Report to the Future Melbourne Committee

Planning Permit Application: TP-2021-224 95 Millswyn Street, South Yarra

19 July 2022

PLANNING PERMIT APPLICATION DELEGATE REPORT

Figure 3 – heritage gradings surrounding the Site, with a grey shading representing ‘non-contributory’ and yellow shading representing ‘contributory’ graded buildings (Source: Council)

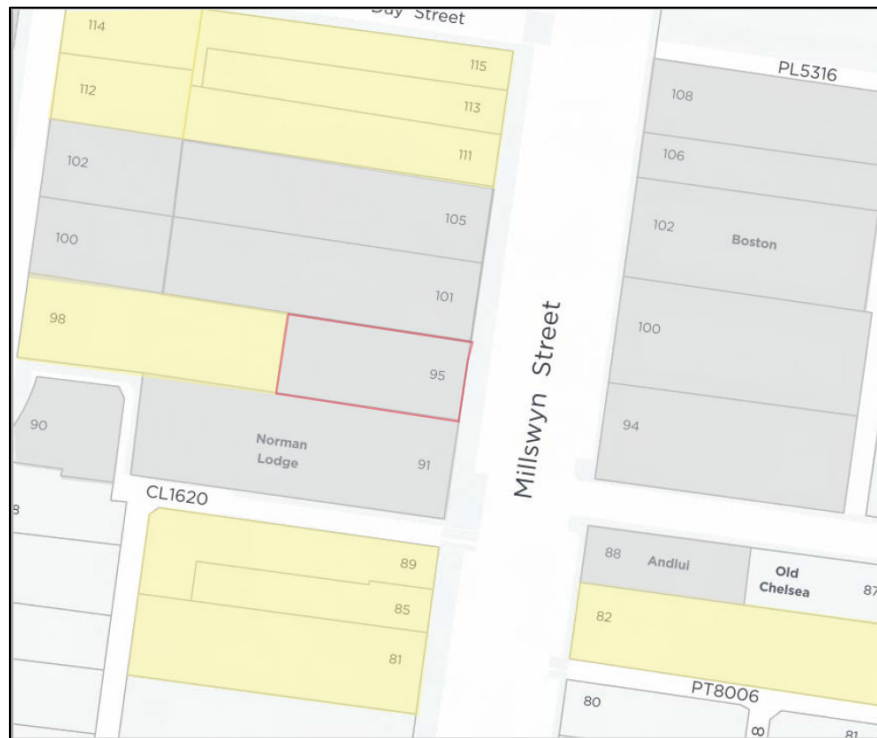
no examples of significant graded buildings, with a majority of buildings being graded as non-contributory as **Figure 3** below shows.

To this point, whilst the dwelling is old it does not appear to clearly possess the key identified heritage components of the South Yarra SoS. Consideration must be given to the level of significance and the context of the building in cases where the heritage area is broad. The assessed significance is discussed above. In regard to context, the Site is located within a pocket of non-contributory buildings – see **Figure 3** above.

Figure 21 – sightline diagram

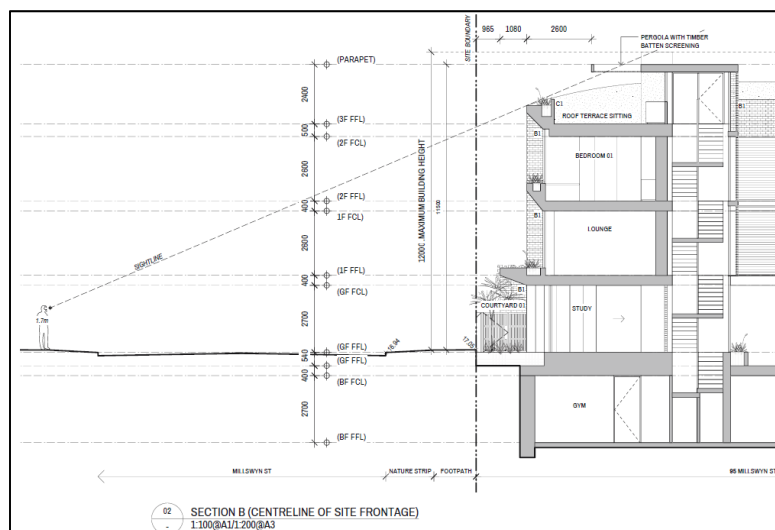
- As per **Figure 3** above, the Site forms a line of four and five non-contributory buildings on the west and east (respectively) side of Millswyn St. This reduces the heritage sensitivity of the Site's location in the heritage precinct. The height of the proposed parapet to Millswyn St is circa 9.5m which is comparable with the circa 9.4m parapet of the building at 91 Millswyn Street and several of the surrounding multi storey buildings. As such, the height of the proposal is considered to be appropriate noting the presence of similarly constructed buildings and the eclectic mix of forms discussed above. Notwithstanding this, it is observed that roof building services and architectural features are not prominent along Millswyn St. As depicted in the sightline diagram (see **Figure 21** below), the rooftop terrace shading pergola will be partially visible to Millswyn St. This is required to be set back further so that it is not visible at a height of 1.7m from the opposite side of Millswyn St which will form a condition should a planning permit issue.

Figure 22 – east and south elevations with A10 setback indicated

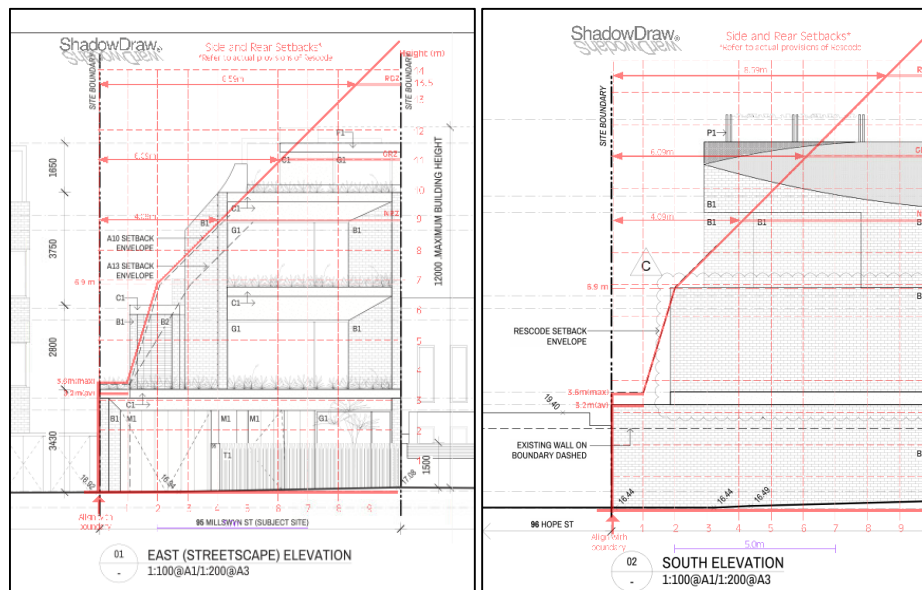
In regard to side setbacks, as depicted in **Figure 22** below, the west and south elevation second and third storeys are non-compliant. The north elevation wall is on a boundary which is assessed under Standard A11 (see below).

Figure 23 – advertised south elevation (left) compared with the 57A reductions (right)

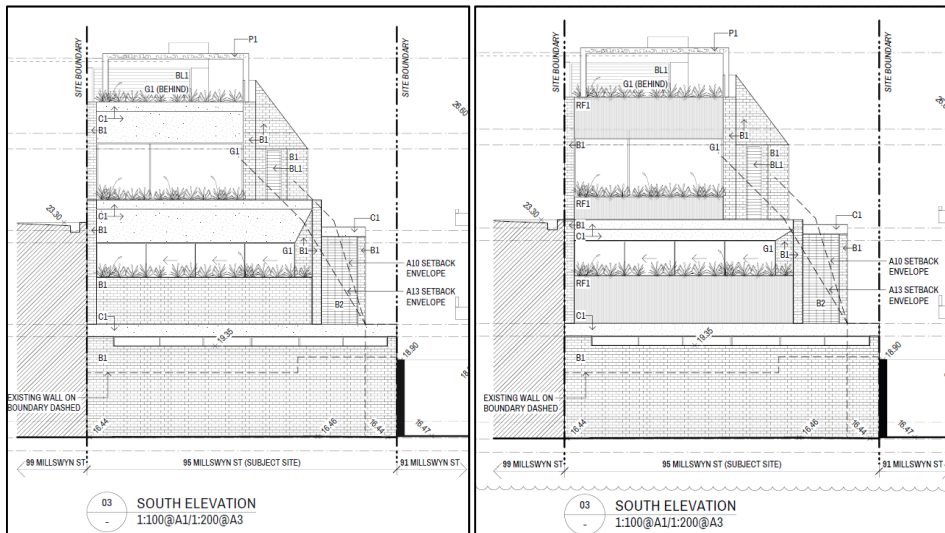
As depicted in **Figure 25** below, dwellings and apartment buildings developed deep into properties is not an uncommon character of the neighbourhood, with the property at 98 Hope St being surrounded by other like forms of similar height. As such, it is considered that the proposal is consistent with the surrounding developments.

Figure 27 – proposed widening of the light court (left) and lowering of the north boundary wall (right)

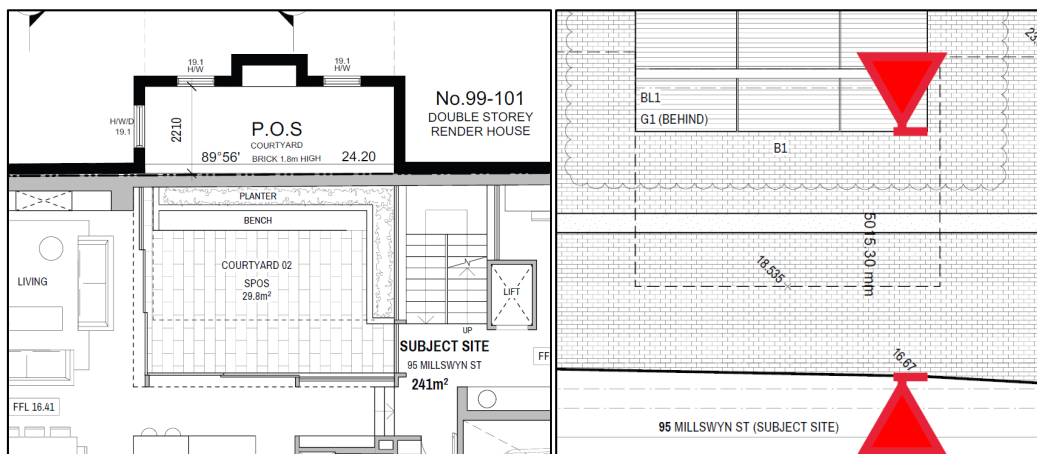
- Figure 26** below (provided to Council) depicts the interface between the existing south facing light court at 99 Millswyn Street and the northern elevation wall of the subject building. The existing northern wall of the subject building is part one storey and part two storeys, with a maximum height 7.6m with a small setback off the boundary. The proposal provides for a part 6.1m (to the top of the light court parapet) and part 10.2m (to the top of the roof parapet) boundary wall.

In response, the applicant provided 57A amended plans to widen the light court to match the width of the courtyard at 99 Millswyn St and a lowering of the wall on boundary to 5.1m – see **Figure 27** below. With these changes, Council officers are of the view that the anticipated visual bulk impacts and amenity impacts to south facing windows at 99 Millswyn St from the subject building are acceptable. The centralised northern internal courtyard proposed is deliberately located to align with the existing south facing courtyard associated with the abutting dwelling at 99 Millswyn Street. This response is site responsive and appropriately responds to existing conditions.

Figure 29 – extract of ground floor plans

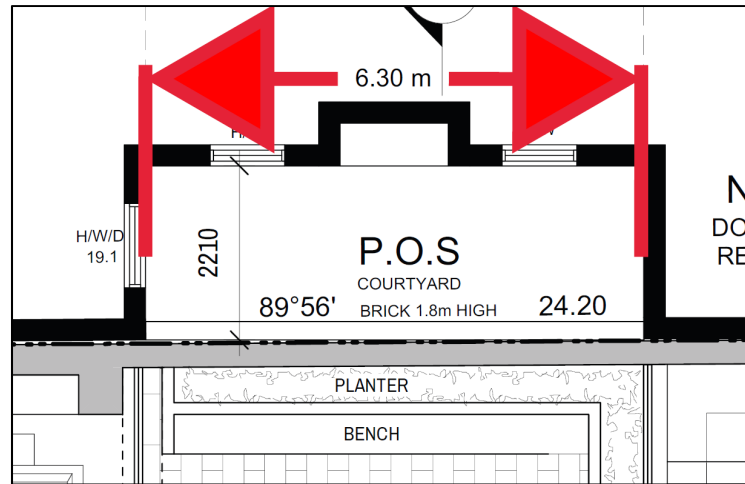
As depicted by the extract of the proposed ground floor below, the proposal seeks to introduce a wall on boundary to the north elevation to the light court of 99 Millswyn St which include habitable room windows. The habitable room windows on the opposite side of the proposed wall on boundary are setback circa 2.23m from the shared boundary. The light court is circa 6.30m wide. As such, the above Standard is achieved.

Figure 32 – east elevation with A13 setback line shown from the FFL taking into account land at 91 Millswyn St

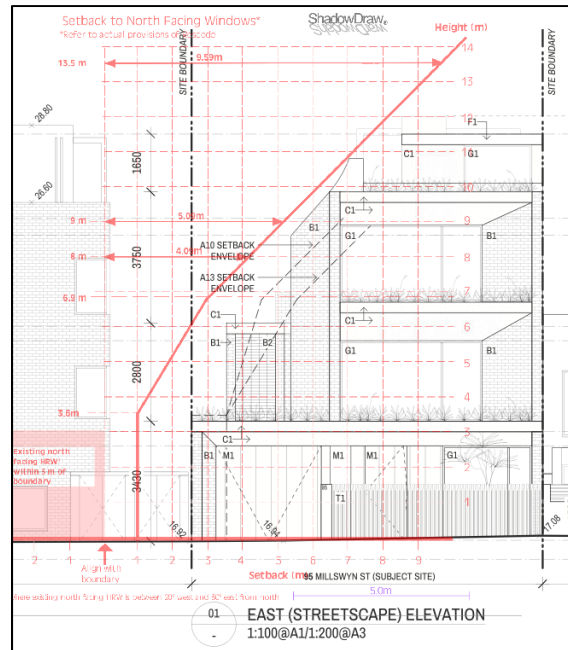
Figure 30 depicts (with a black dotted line marked 'A13') that the proposal does not comply with the setback requirements of Standard A13. The variation sought to Standard A13 is acceptable, having regard to the decision guidelines of Clause 54.04-4, noting the following:

- Opposed to Standard A12 which can be taken from the floor level of the room containing the window, Standard A13 is taken from the title boundary at ground floor. However, in cases such as *Pincent Hotel Pty Ltd v Melbourne CC [2022] VCAT 550* (see Paragraph 79) the Tribunal has considered that (within an inner city context) taking the A13 setback line from the finished floor level of a window is an appropriate response to understand whether the Objective is met. As depicted in **Figure 31**, the proposal would comply with the Standard A12 setback line if taken from this location. This is further emphasised by **Figure 32**, which confirms that if the setback line included the space on an abutting lot the Standard would also be achieved. It is noted that the existing two storey dwelling at the Site is an existing non-compliance with Standard A13, and as such the proposal would present an improvement. Whilst the proposal is a non-compliance with the Standard, having regard to the above and the improved conditions, it is acceptable.

Figure 32 – section diagram with sightline drawn by Council

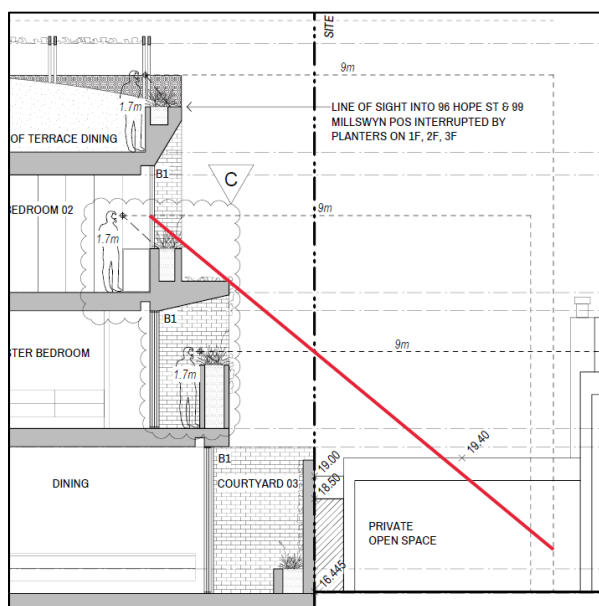
- North: as per First Floor above.
- South: as First Floor above, however a permeable screen is utilised to ensuite 01.
- West: the plans seek to rely on an inbuilt internal desk to further limit overlooking. This is not considered acceptable given the use of a dwelling does not require a permit, therefore Council cannot require the desk to be installed in this location. However, as **Figure 32** below shows, if the view is taken from the edge of the window (as required by the Standard) the proposed planter will prevent views to the ground floor SPOS of 98 Hope Street within 9m in accordance with the Standard. There are no habitable room windows in this location to 98 Hope Street. However, the plans do not make clear enough if views are sufficiently limited to the rear SPOS of 91 Millswyn Street and 99 Millswyn Street. As such a permit condition will require this detail to ensure no unreasonable views are available in accordance with Standard A15 and for any associated modifications to ensure compliance if required.
